## MooresCloud Holiday Engineering Change Order ECO 001 for Holiday r2 PCB

18<sup>th</sup> October 2013

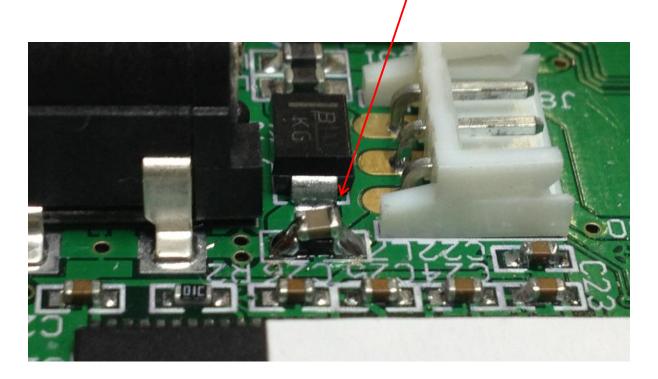
To meet EMC radiated emissions requirements, the following three changes should be made to each Holiday Controller revision 2 PCBA

- 1) Populate C54 with 680pF 50V NPO ceramic capacitor (0603 size, although 0805 fits as shown in photo below)
- 2) Remove L6 and short the pads with solder (or a OR resistor, 0603 size)

3) Add "C58" – a 1uF 50V X7R ceramic capacitor (0805 size) across L7
